# Comments on applications for referral under the COVID-19 Recovery (Fast-track Consenting) Act 2020

Project name	Ngongotahā Housing Development, 31 Ngongotahā Road, Rotorua
General comment – potential benefits	<p>The project will result in the construction of 196 household units with a mix of affordable housing and social housing. It is acknowledged that there is a housing shortage within the Rotorua District and there will also be economic benefits from the proposal.</p> <p>The project will also involve the construction of pedestrian and cycle accessways, public open spaces, restoration planting (adjacent to the riparian corridor), stormwater reserves and a wetland.</p>
General comment – significant issues	<p><b>Staged Approach to the Development of the Site</b></p> <p>We have previously provided the following advice to the applicant. This is contained within the technical memo also attached to this response.</p> <p><i>In recent times, the Rotorua area has been subject to a number of larger flooding events with significant consequences including the nearby Ngongotahā and Utuhina catchments. This has prompted BOPRC to carefully consider the impacts of proposals to urbanise land,

Figure 3A: Proposed discharge to the existing RLC Road Drainage System

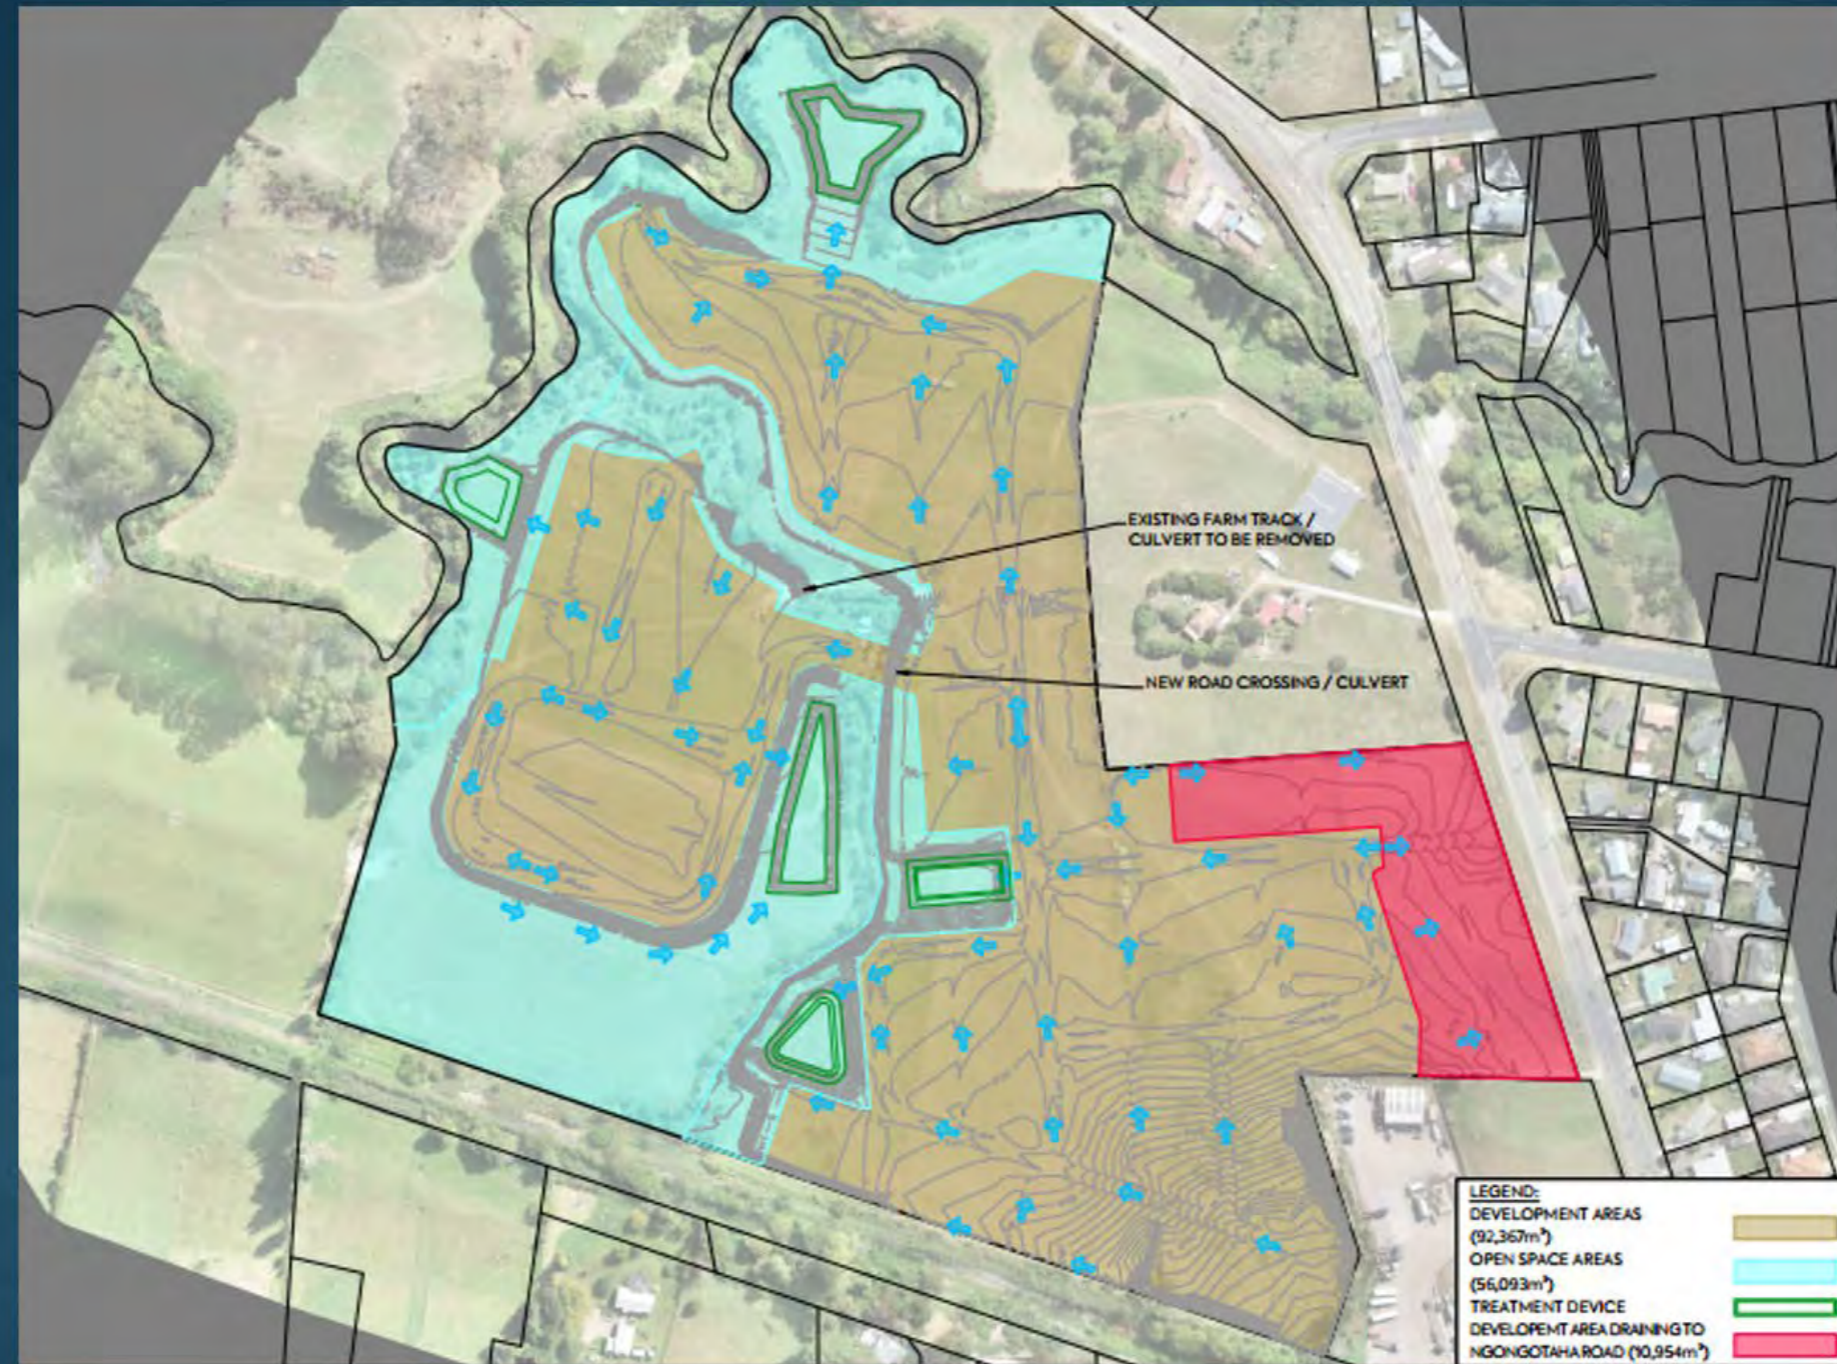
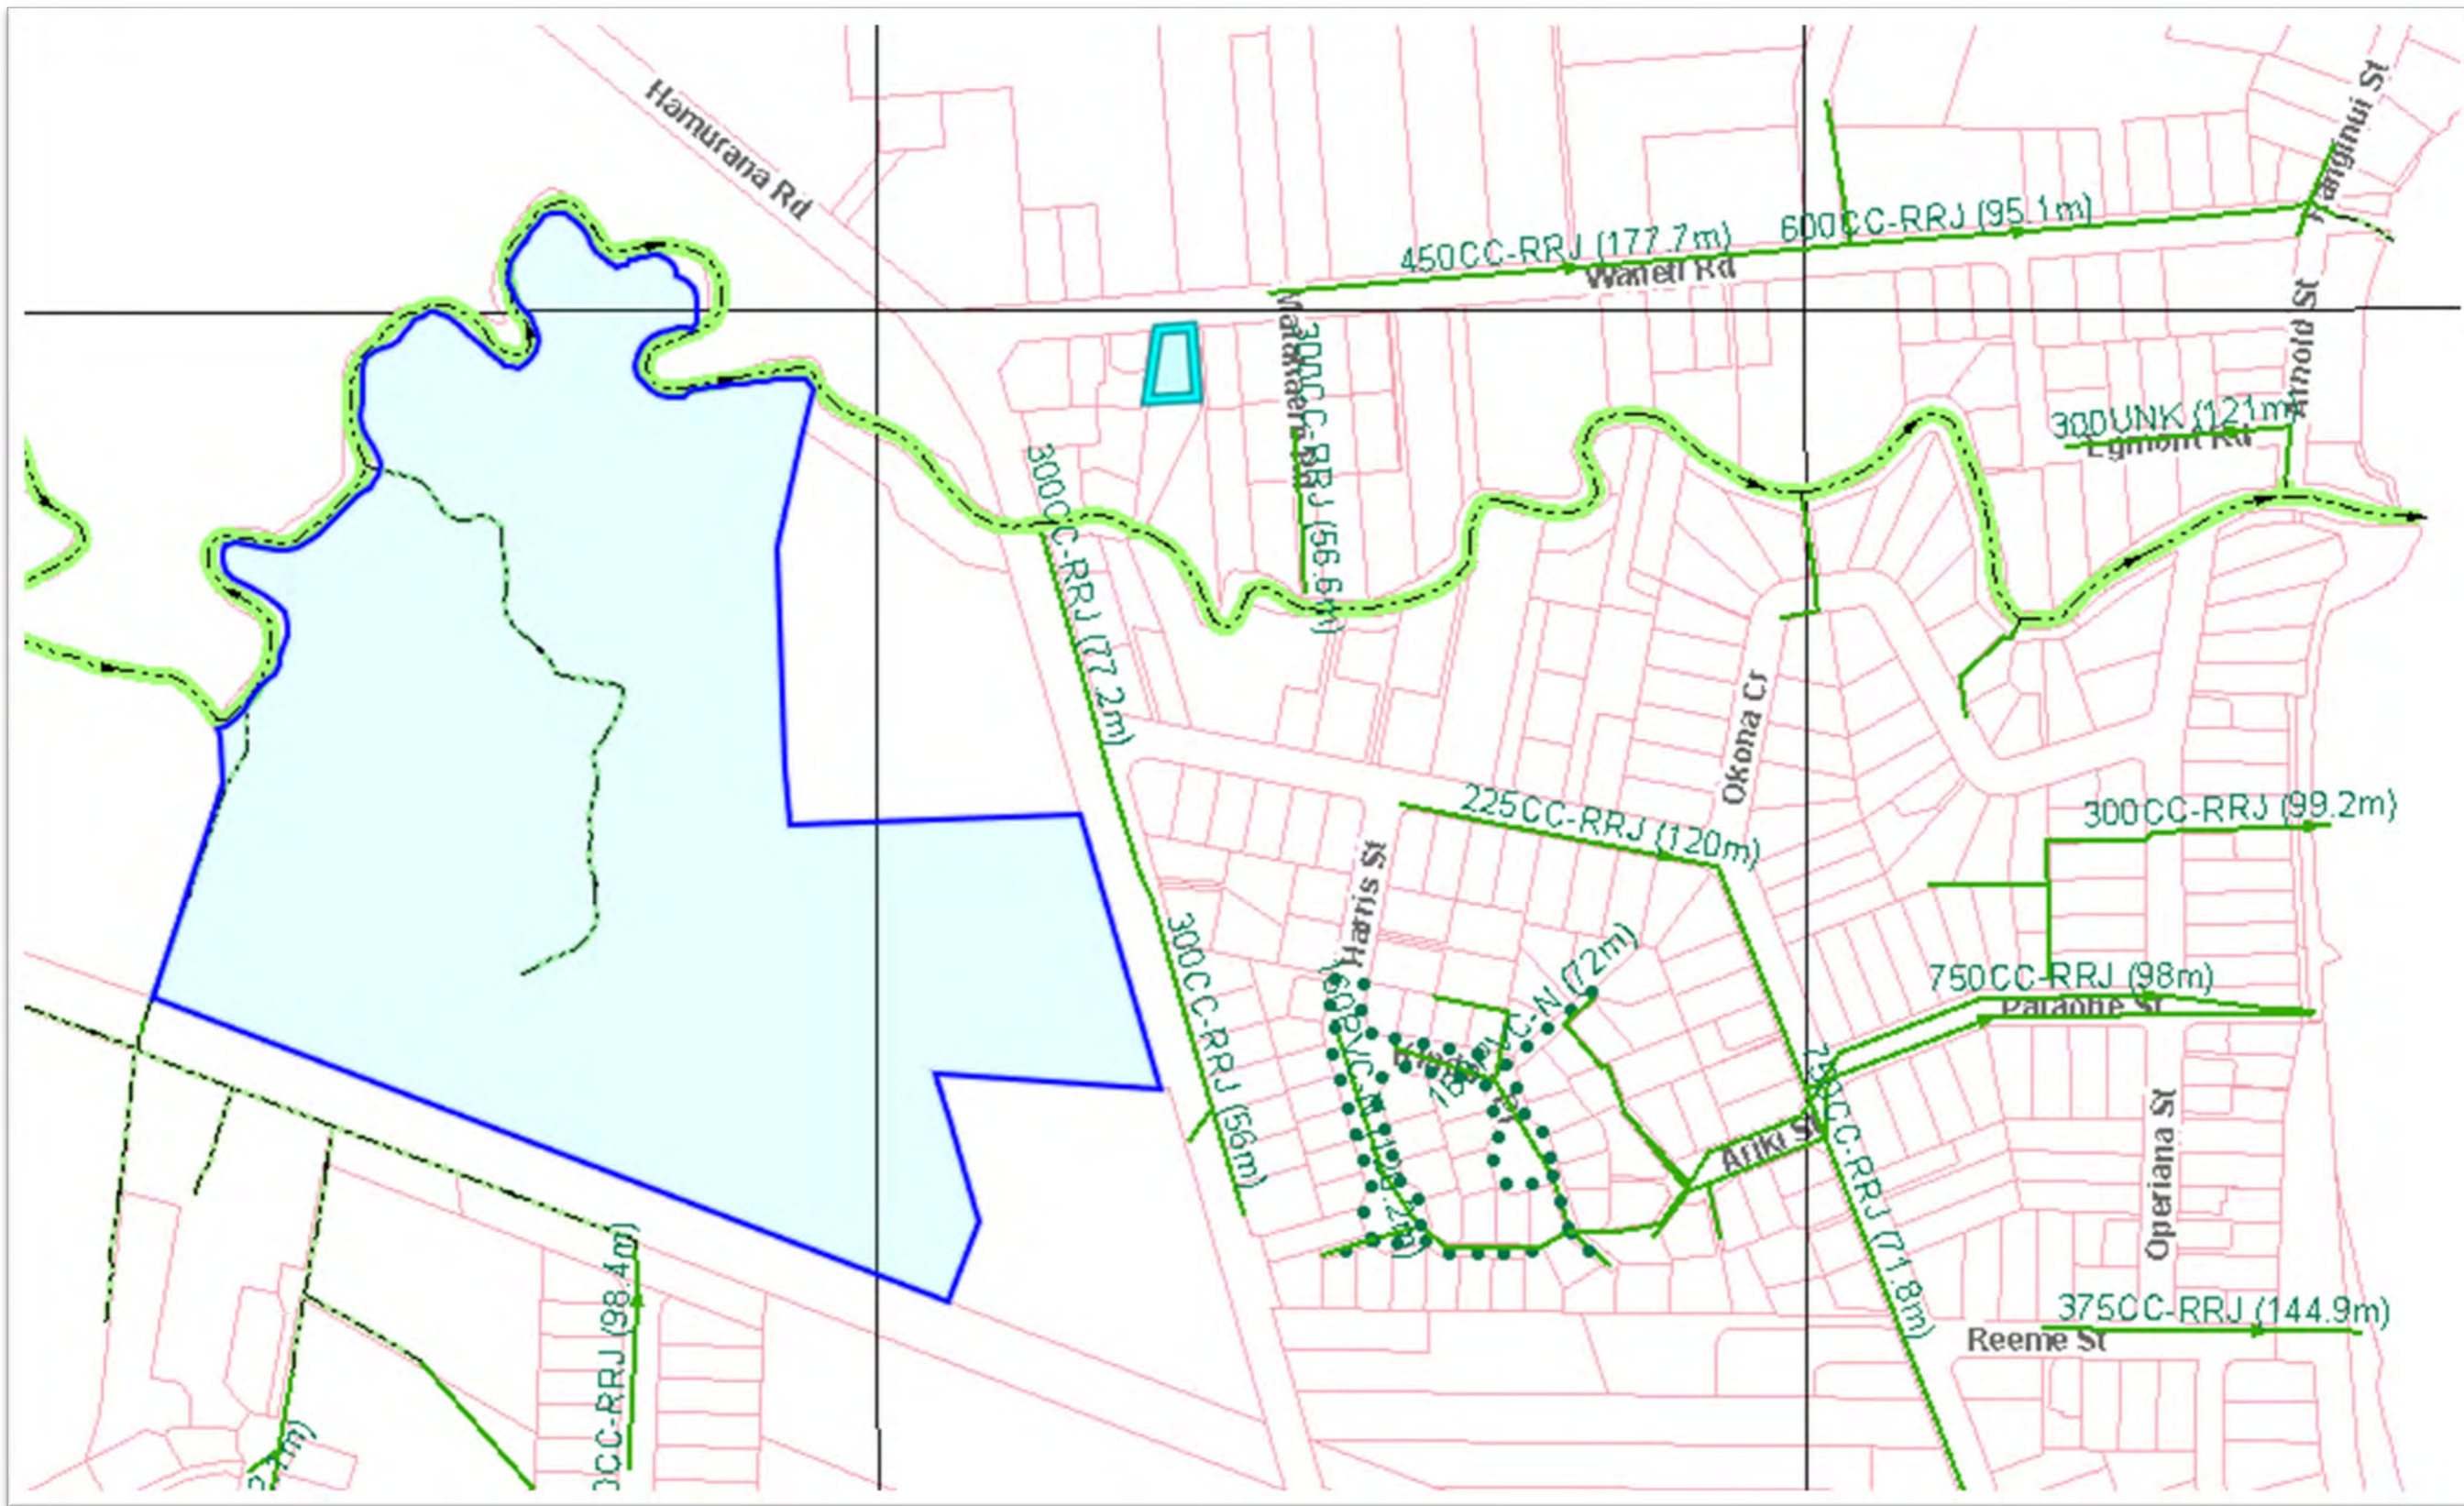
Part of the proposed development (approx. 1.1ha, highlighted in red in Figure 3A on Page 11) is shown to be connected to the RLC road drainage system in Ngongotahā Road. This system is small (300 mm diameter pipe), and it will be necessary to demonstrate that system capacity is available or upgraded if required. Further, neither the recurrence interval nor whether the discharge will be mitigated (prior to discharging into the reticulated system) has been explained in the presentation document. **(See Figures 3A & 3B on Pages 11 & 12).**

It is our understanding that RLC had previously advised the former developer and his agent that the existing road drainage system doesn't have the capacity to receive any stormwater from the proposed development. Further detail on this aspect is required to be able to assess the associated effects of the discharge.

The discharge will need to be mitigated prior to discharging into the Waiteti Stream to prevent an increase in runoff from the site in a climate change adjusted 100-year event. This detention should be to a minimum standard of 80% of pre-development peak discharge in accordance with the Stormwater Management Guidelines for the Bay of Plenty region (BOPRC Guideline 2012/01).
